7.1.2 SCOTCHMANS CREEK TRAIL TO DJERRING TRAIL CYCLING CONNECTION

Feedback Report: Cycling Connection between Scotchmans Creek Trail and Djerring Trail

Via Atkinson Street, Oakleigh

1. Atkinson Street functional design [7.1.2.1 - 1 page]
2. Atkinson Street Feedback Report [7.1.2.2 - 47 pages]

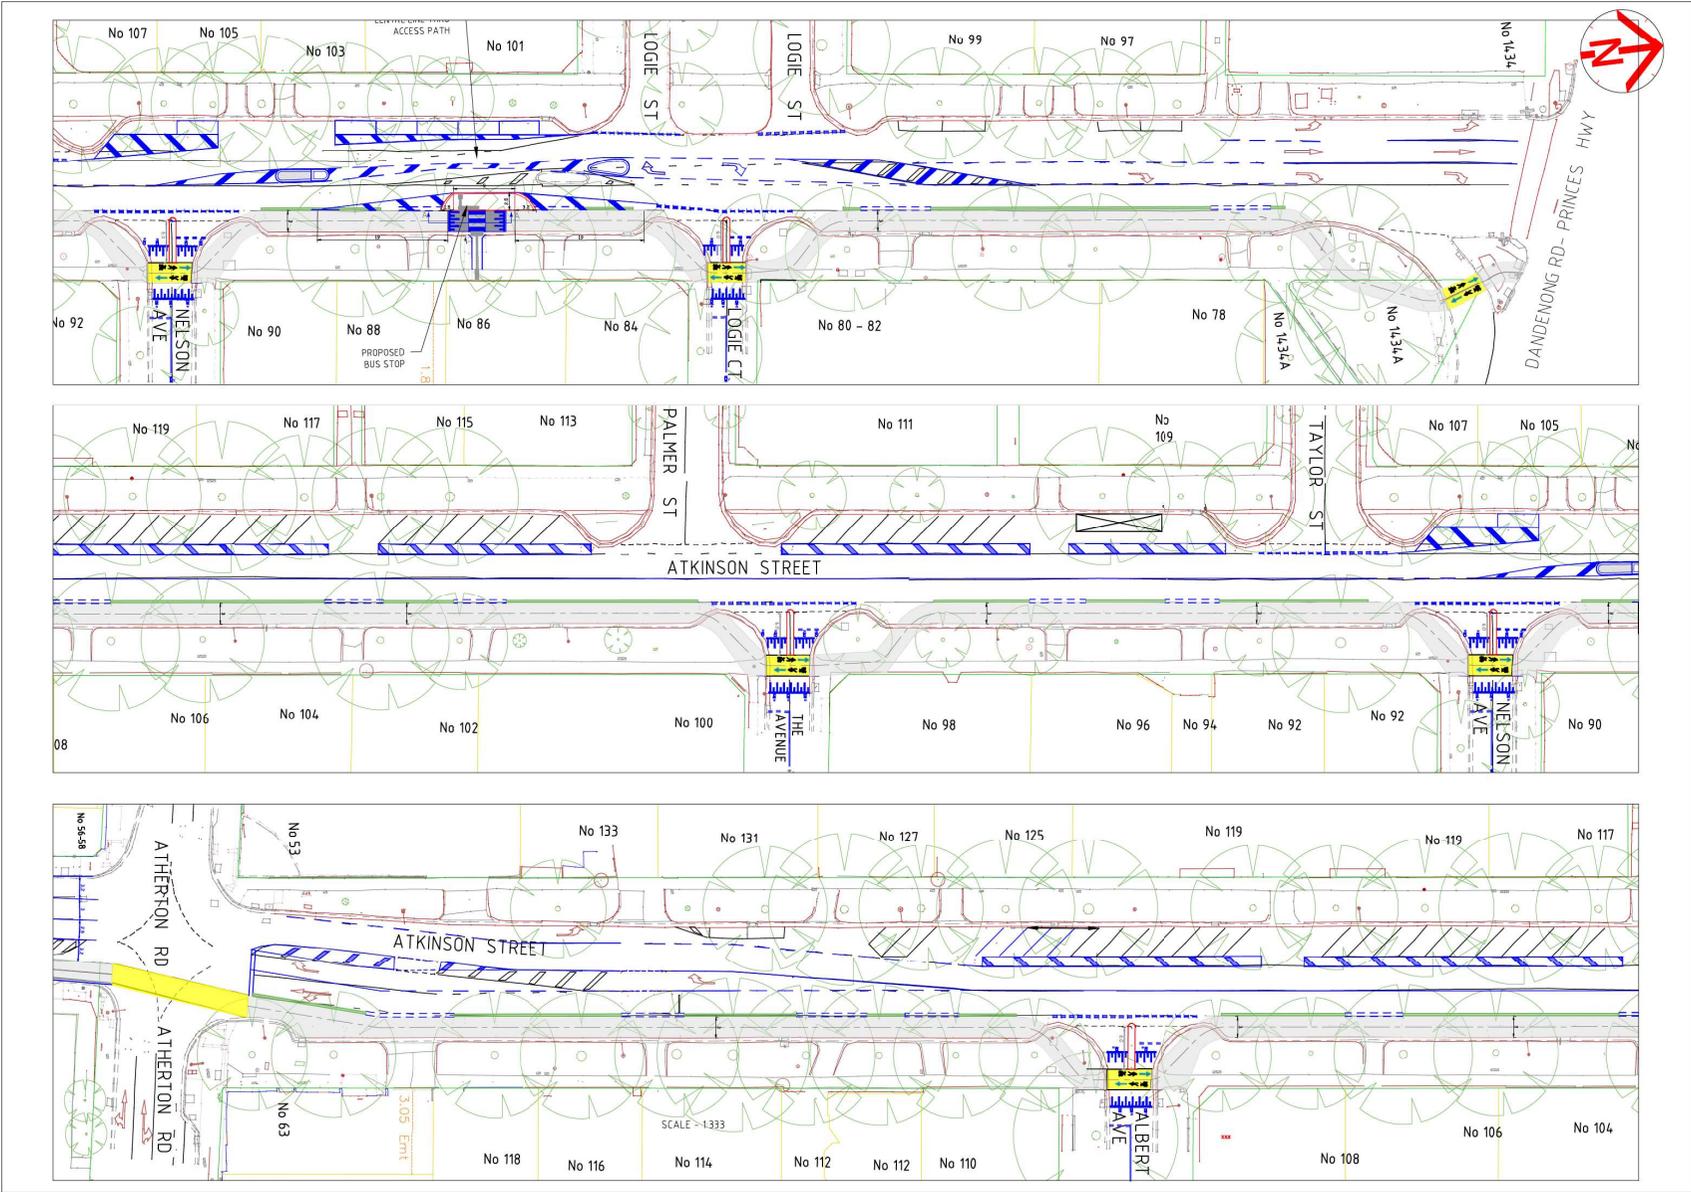
<p>C7 – Shape Monash</p>	<p>I ride my bike, and drive along Atkinson Street frequently. I support this plan, however, just have a few things I have noted.</p> <p>The bends towards the "bent out" cycle crossings appear too sharp. The AustRoads guidelines recommend a turning radius of 30m on the approach and specify that the aim of a bend out is to allow the storage of a car waiting to cross, rather than to slow approaching cyclists. It also advises that having such sharp turns focuses a cyclists attention on their maneuver rather than on the crossing and its potential hazard. The transition of the bike only path to a shared path at these crossings could also pose a risk with such sharp bends. Cyclists' line of sight to pedestrians should also be considered. However, if the alternative to sharp bends is having a straight crossing where cyclists and pedestrians</p>	<p>Further information relating to the 'bend-out' treatments is provided in the Officer report at Theme 3 – Safety Concerns.</p>

<p>C11 – Shape Monash</p>	<p>I have safety concerns about having angled parking on a 60 kmh road. Surely it is not considered safe for drivers and they should be removed to make way for parallel parking with buffers on both sides of the street?</p> <p>Has a safe system assessment by an independent consultant been done on the proposed design?</p>	<p>Atkinson Street is a 40km/h and 50km/h road. No changes will be made to the angled parking on the west side. The existing on-road bike lane on the west side will be converted to a chevron linemarking separator which will assist motorists exiting these spaces.</p>

<p>Item 6 on your Concept Plan uses terminology that I do not understand. It says '6. Implement traffic calming'</p> <p>With the street south of Burlington St not exceeding 200 metres in length, the majority of drivers would never exceed 30-40 kilometers per hour so what does Traffic Calming mean please ??</p> <p>How do you think that will ensure the safety of the cyclists and the existing pedestrian public ??</p>	<p>Traffic calming treatments proposed are raised crossings at the intersection of Burlington Street/Oxford Street and linemarking of bike sharrows that encourage motorists and cyclists to share the roadway. Examples of existing sharrows can be found along Kanooka Grove, Clayton.</p>
<p>C61 - Email</p>	<p>I hope this email finds you well. I am writing to express my concerns regarding the safety of cyclists in the area, particularly along Atkinson Street where it intersects with Princess Highway going south bound toward Djerring trail. I believe that establishing a separate and protected bike lane is essential to ensure the safety of cyclists and prevent potential accidents. I recently had a near miss incident at this location that I have attached picture name princessshwy.jpg of the location, and I would like to bring some issues to your attention.</p> <p>The specific location of concern is the intersection of Atkinson Street and Princess Highway, where there are three lanes of traffic plus an additional lane for left turns. The problem arises when the bike lane abruptly ends before Quinces Coaches, forcing cyclists to merge with vehicular traffic in the left lane. Beyond this point, the road narrows to a single lane on the north side of Atkinson Street after crossing Princess Highway. This configuration has led to situations where I have experienced dangerously close encounters with impatient drivers who overtake from the very left lane, leaving me feeling extremely unsafe.</p> <p>Furthermore, the parallel parking along the east side of Atkinson Street poses a significant risk of "dooring" incidents for cyclists. It's crucial that these potential hazards are addressed to improve safety for all road users.</p> <p>I appreciate the council's proposal for a separate cycling lane and am pleased to see progress in this regard.</p> <p>I have questions about the proposed design changes:</p> <ol style="list-style-type: none"> 1. Will there be a traffic light at raised pedestrian/bike crossing at this intersection, as indicated in the 	<p>It is agreed that changes to the Dandenong Road and Atkinson Street intersection are required and Council officers will advocate to DTP for improvements including a raised pedestrian and cyclist priority across the slip lane.</p> <ol style="list-style-type: none"> 1. Council will advocate to DTP for the slip lane crossing to be a

Given bi-directional on-road bicycle lanes are less common in Victoria, queries about their safety are to be expected. However, it is important to note that the preliminary design has been developed in conjunction with an external specialist transport consultant and is in accordance with Australian Standards. Risks have been assessed as part of the design and mitigated by removing all parking on the east side to maximise sight lines and creating separation between the cycle lane and traffic lane for vehicles turning into Atkinson Street. The radius of the bends on the cycle path will be refined in the detailed design, being mindful of limiting any impact on the existing nature strip trees. However, it should be noted that these bends are an important design element to reduce cycle speed when crossing roads.

This issue is addressed through the design where the proposed raised crossing treatments will be set back approximately one car length at side streets which will allow motorists to traverse the cycleway prior to reaching the Atkinson Street carriageway so they will not need to look for cyclists and motorists at the same time.

The design for the Hanover Street section of the cycleway retains the right turn lane into Chester Street. Access into the Hanover Street car park may require review. The cycleway is not expected to significantly increase congestion in this area.
